Accessibility Design Review Report – SSDA

Project Title: Kingswood TAFE - (Construction Centre of Excellence)
2-44 O'Connell Street, Kingswood

Job Number: 20282

Report Version: ADR_20282_SSDA_v1.1

Cl. D3.2: Access to Buildings

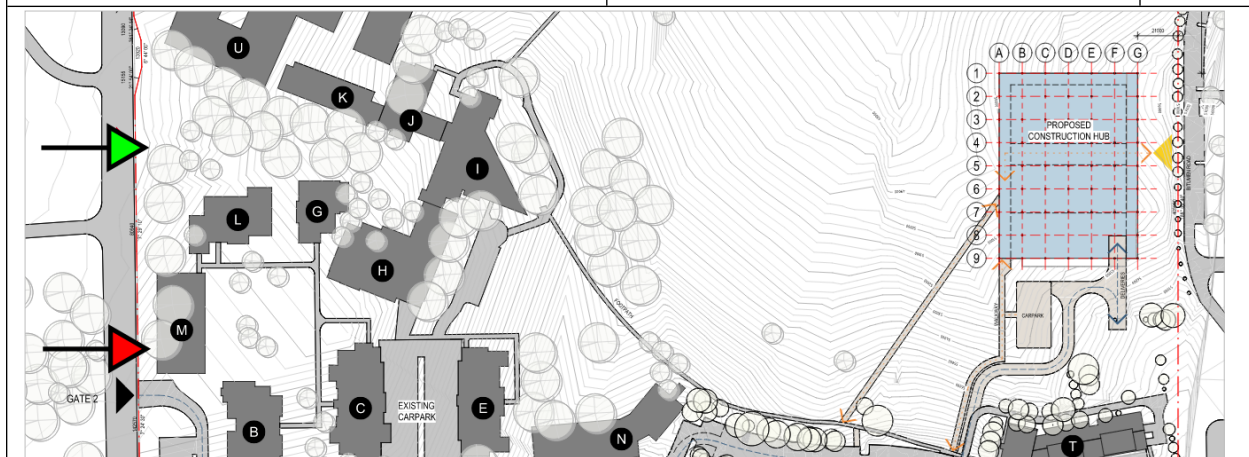
DtS Provision	Comment(s)/Recommendation(s)	Status
<p>An accessway must be provided to a building required to be accessible –</p> <ul style="list-style-type: none"> • from the main points of pedestrian entry at the allotment boundary; and • from another accessible building connected by a pedestrian link; and • from any required accessible carparking space on the allotment. <p>In a building required to be accessible, an accessway must be provided through the principal pedestrian entrance, and –</p> <ul style="list-style-type: none"> • through not less than 50% of all pedestrian entrances including the principal pedestrian entrance; and • in a building with a floor area more than 500m², a pedestrian entrance which is not accessible must not be located more than 50m from an accessible pedestrian entrance. <p>except for pedestrian entrances serving only areas exempted by D3.4.</p>	<p>Access is required from the main points of pedestrian entry at the allotment boundary, from associated accessible carparking spaces and from another accessible building connected by a pedestrian link to the subject building.</p> <p>Allotment Boundary</p> <p>The campus has 2x existing pedestrian entries at the allotment boundary of O’Connell Set, the southern most appears to be the oldest and has several associated compliance departures to current standards.</p> <p>The northern pedestrian entry appears to have been constructed recently, potentially in conjunction with Building U, and was noted generally suitable for access for persons with a disability.</p> <p>There are several existing pedestrian pathways running through the campus from these entries, eventually converging to one path leading to buildings P & T. These pathways all have several non-compliances to current accessibility requirements/standards.</p> <p>Given the level of non-compliance of the existing external pathways, it is recommended to utilise the newer path and passenger lifts of Building U and construct a new pedestrian pathway to the proposed site.</p>	<p>CoC</p>

<p>While new pathways are ideal, it is understandable that this can be difficult when considering budget constraints on a site of this size and topography.</p> <p>As such, student/staff centred access management plans could be considered alongside performance solutions as a way of satisfying accessibility requirements on a case-by-case basis.</p> <p>This would be an appropriate solution as the buildings intended purpose is focused on trade & technical education, where accessibility would relate more to ambulatory impairments.</p> <p>Accessible parking</p> <p>New accessible parking is proposed adjacent the construction Hub and shall be provided with compliant pedestrian access.</p> <p>Other accessible buildings</p> <p>There are several existing, non-compliant pedestrian pathways provided between the buildings. It is interpreted that only the new portion of pathway connecting to the existing pathways is required to comply, though it is still recommended to upgrade access between all connected facilities.</p>

Cl. D3.3: Parts of buildings to be accessible

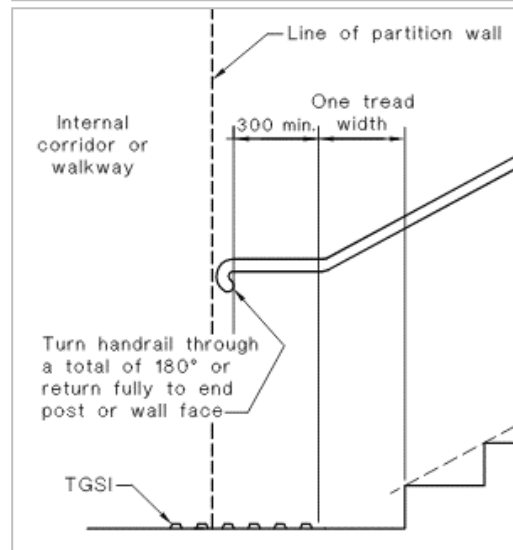
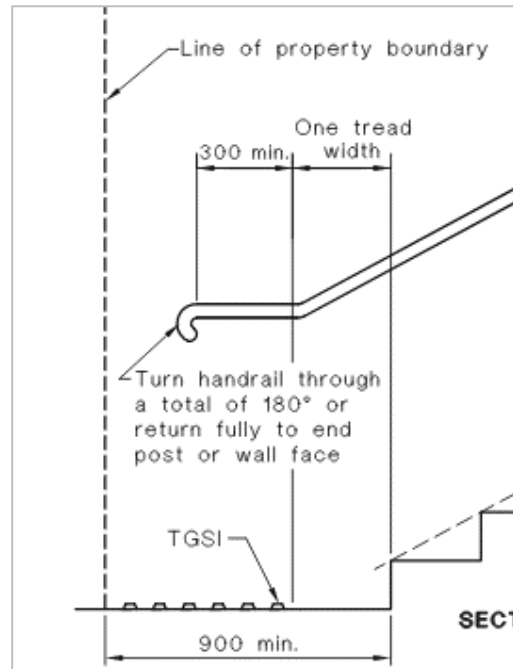
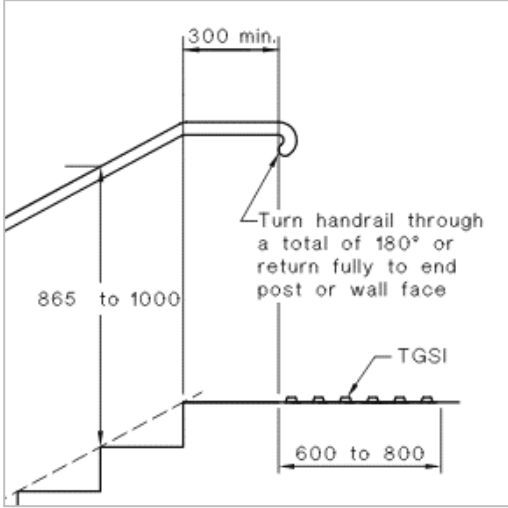
DtS Provision	Comment(s)/Recommendation(s)	Status
In a building required to be accessible every ramp and stairway, except for ramps and stairways in areas exempted by D3.4, must comply with –		
<ul style="list-style-type: none"> for a ramp, except a fire-isolated ramp, clause 10 of AS 1428.1; and 	<p>Ensure all walkways (regardless of gradient) and ramps are provided with the associated accessible features such as handrails and TGSIs in accordance with AS1428.1 & AS1428.4.</p> <p>Compliance is otherwise readily achievable with minor design development and/or specification to BCA & AS1428.1-2009 at the Detailed Design Stage.</p>	CoC

- for a stairway, except a fire-isolated stairway, clause 11 of AS 1428.1; and

Ensure accessible features and FF&E such as handrails and TGSIs are provided in accordance with AS1428.1-2009 where steps/stairways are provided.
